FINAL
ENVIRONMENTAL IMPACT STATEMENT

F-15E BEDDOWN AT SEYMOUR JOHNSON AFB,
NORTH CAROLINA

November 18, 1988

FIGURE 4.2-1
PROPOSED ACTION
NOISE MAP-BASE

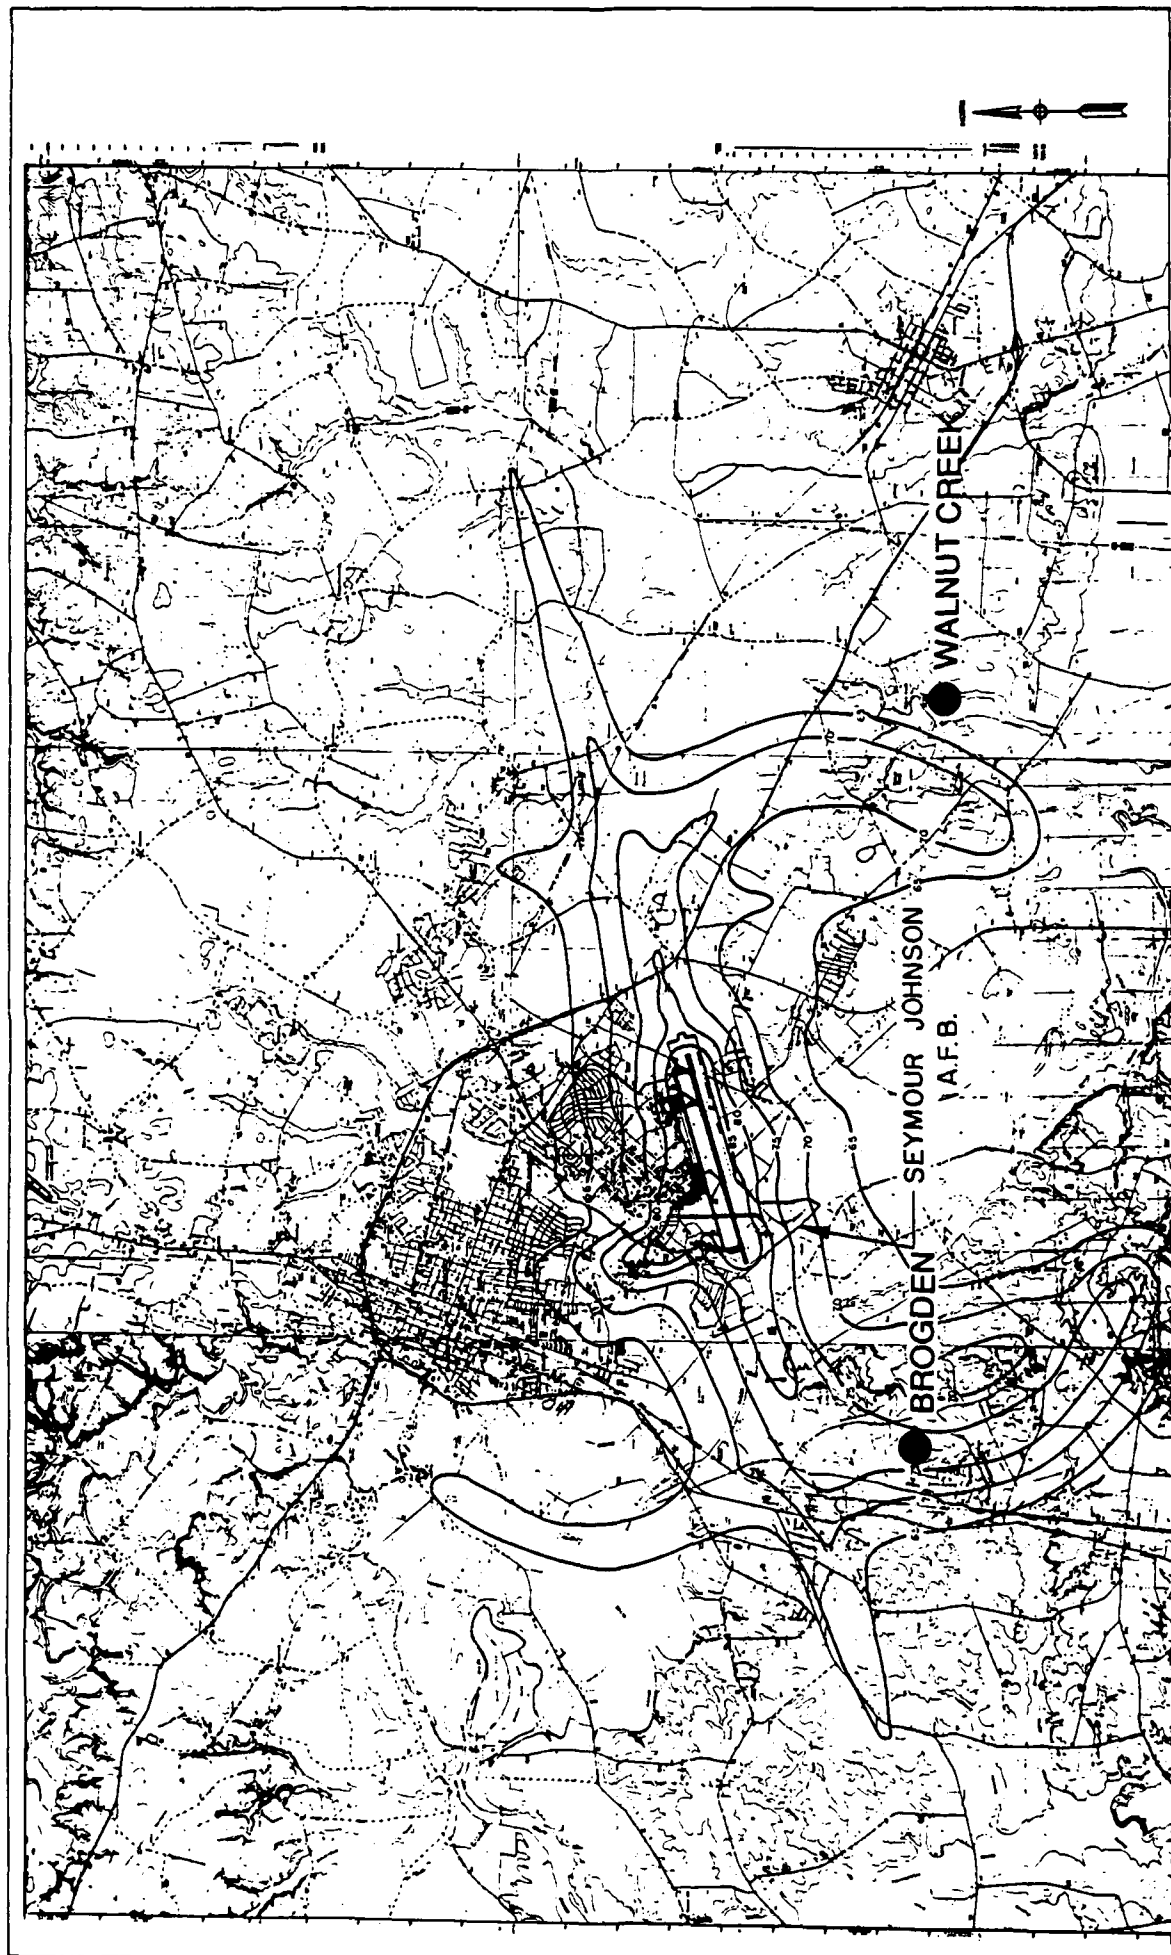
- 1) improvement of Figures 3.2-2 and 3.2-3, so they are to the same scale;
- 2) identification (on the maps) of the "worst case" affected communities;
- 3) presentation in Table 4.7-3 of the "worst case" noise levels, after the 20 dB changes have been added to the ambient; and
- 4) that mitigation be examined if the "worst case" elevations are in excess of standards adopted by the Air Force.

7. In line with comment 4, Figure 3.2-2 only provides a benchmark for showing the noise contours during the 1983 time period. To gauge the short term impacts, the reader should compare Figures 3.2-3 and 4.2-1 which are comparably scaled. Brogden and Walnut Creek have been identified on the maps which are provided in the errata section of this document. Tables 4.7-3 and 4.7-4 both represent "worst case"; the change in the noise level column represents the difference between a value of 55 DNL or the comparable compatible use district (CUD) from Figure 3.2-3. (if the area in question is within the AIC/JZ), respectively.

18. p. 3.4-12, 3rd paragraph, last line: Change Figure 3.0-1 to 3.0-2.
19. p. 4.2-2, Figure 4.2-1: See revised Figure in this section.
20. p. 4.2-4, 2nd paragraph, 3rd line: Change 38 to 14.

● Approximate locations of "worst case" increases in sound level due to the proposed action.

MILITARY TRAINING ROUTE MAPS

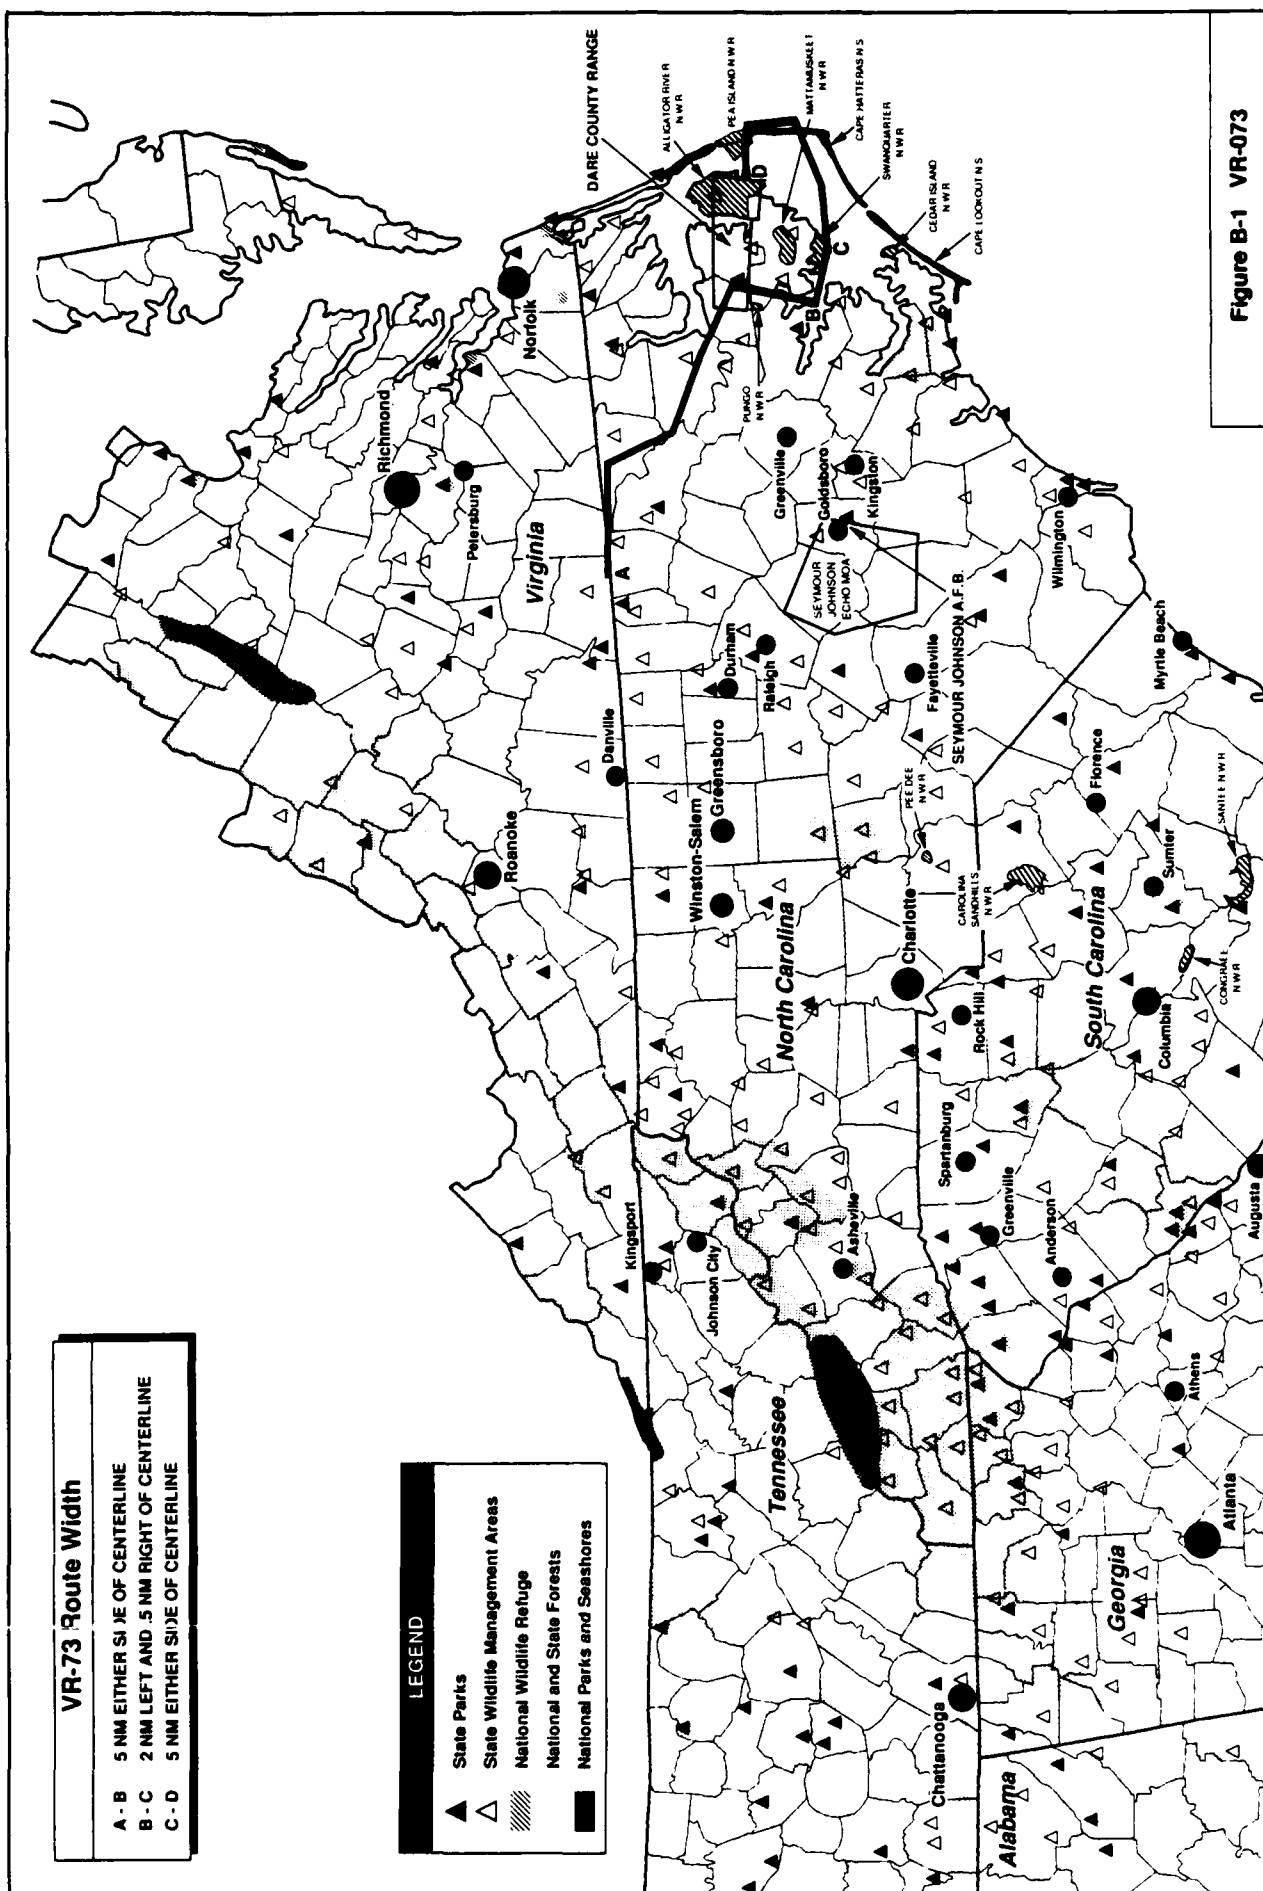
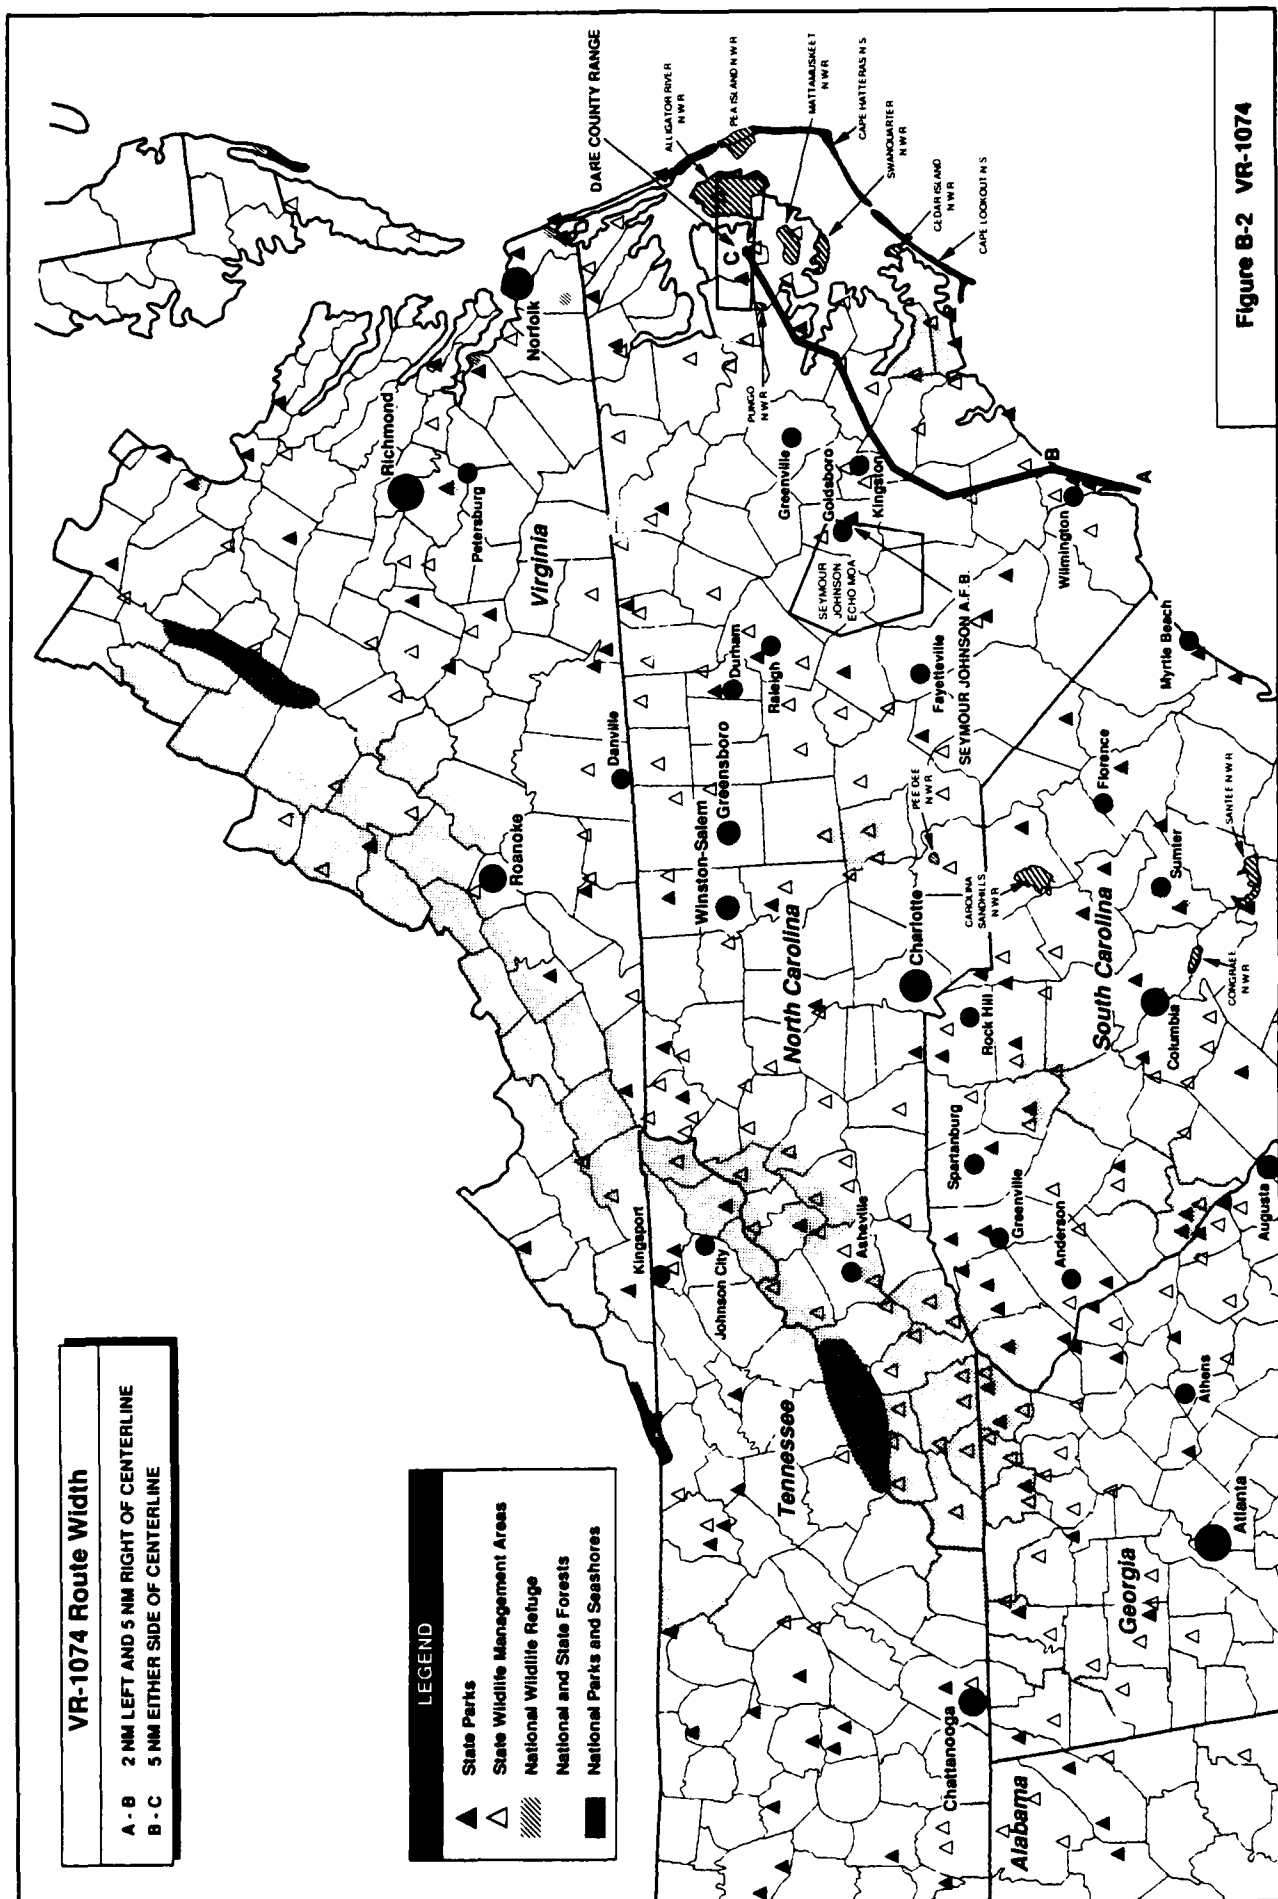
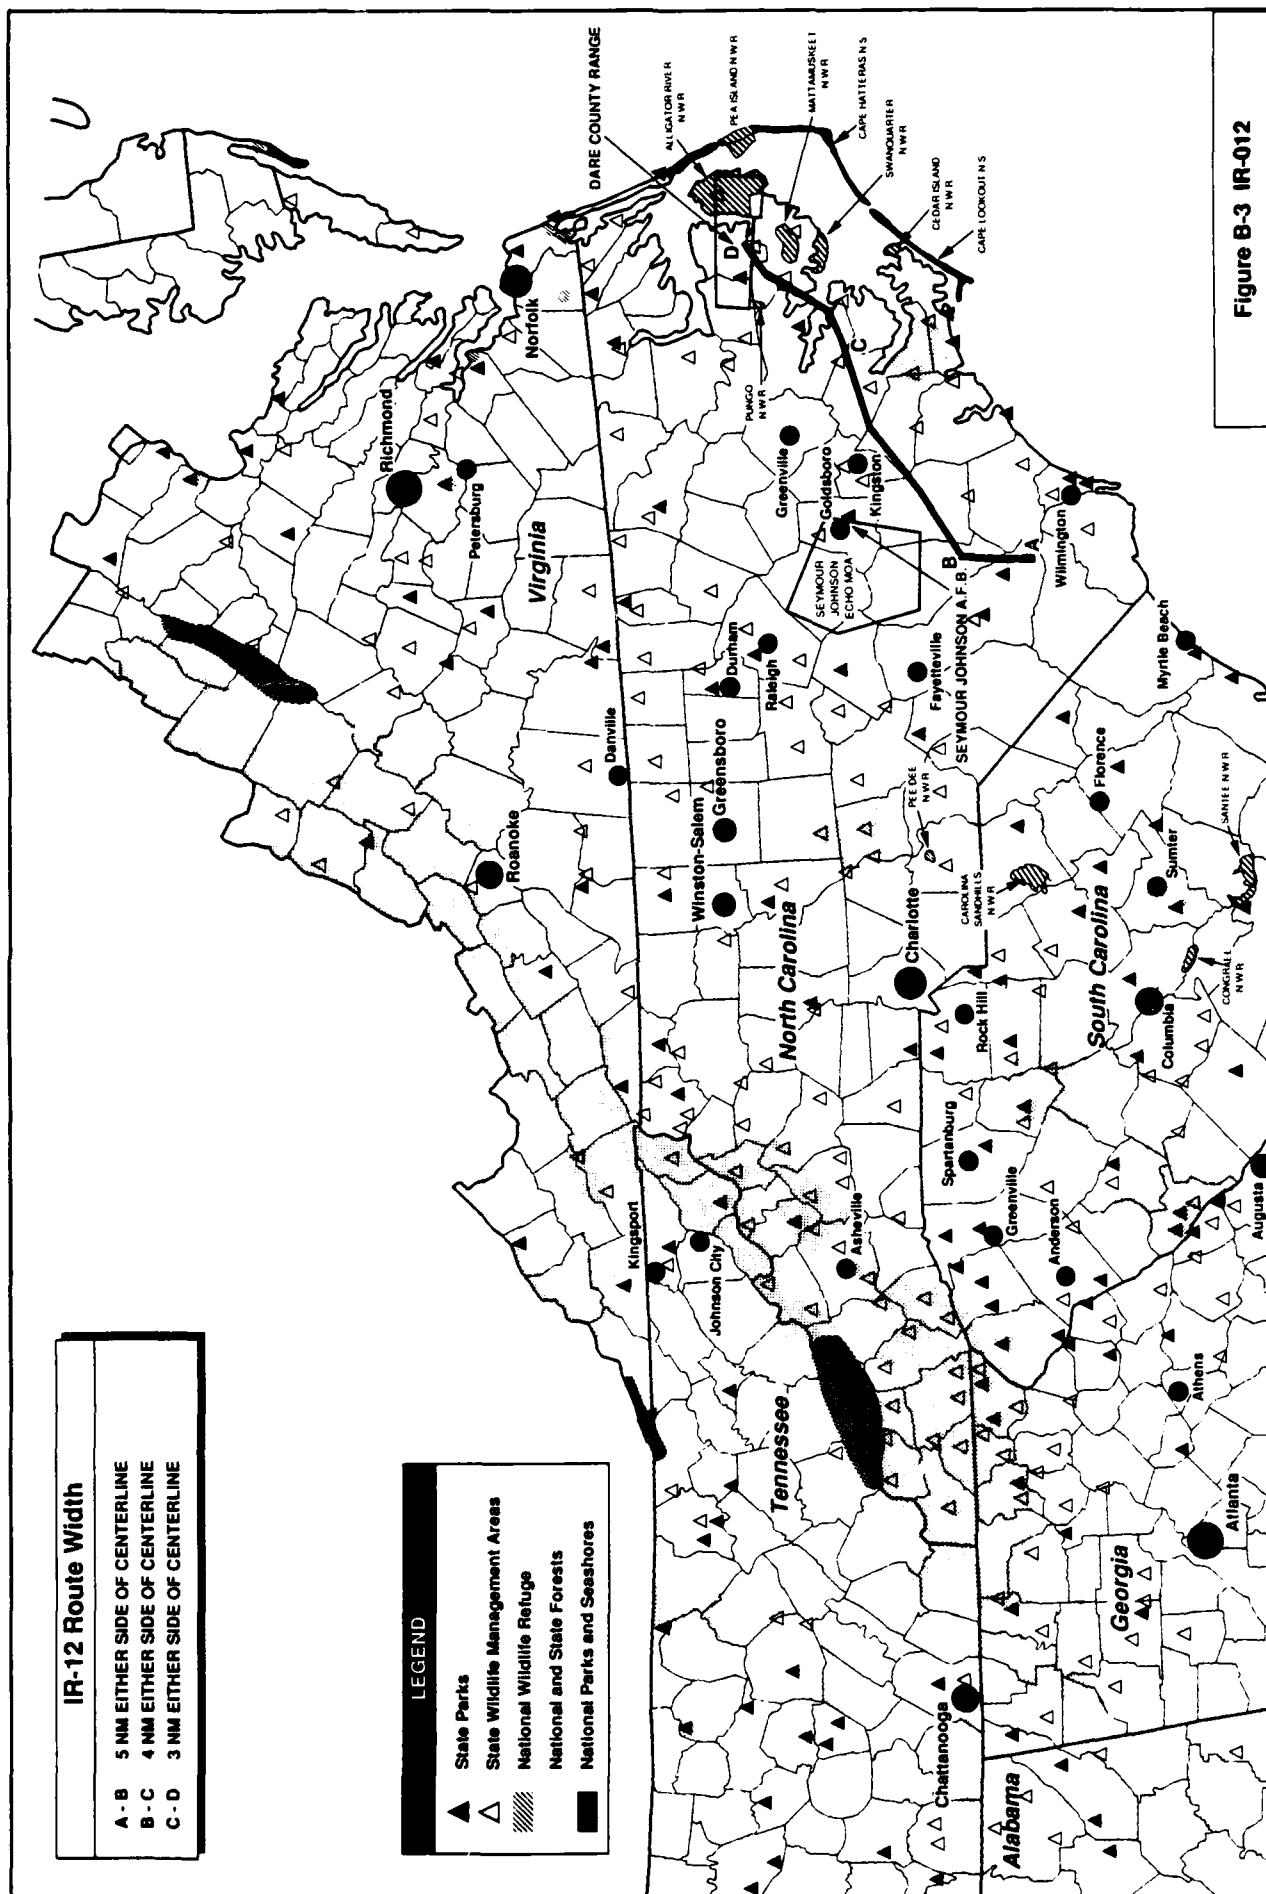
Page 3.0-3. Figure 3.0-2 only qualifies as a general representation of the MTR proposed for use and is not sufficient

to show their relationship with other facilities. For instance, neither R-5301 and 5302 nor R-5313, or Pamlico MOA are on the map. It is impossible to identify the location of any site in the interior of the state if it is not on the map.

77. The correct reference is to Figure 3.0-2. See errata (Chapter 5). Additional information on the location of "wildlife management and recreation areas" is provided in Appendix B.

13. p. 2.4-2, Table 2.4-1, Impact Area, No Action Alternative, and Proposed Action columns: Insert "Fire Potential", 0, and 0, respectively.
14. p. 3.0-3, Figure 3.0-2, VR-096 and VR-1043. Routes were drawn beyond legs specified in AP1B extracts for MTRs. See revised maps in Appendix B.
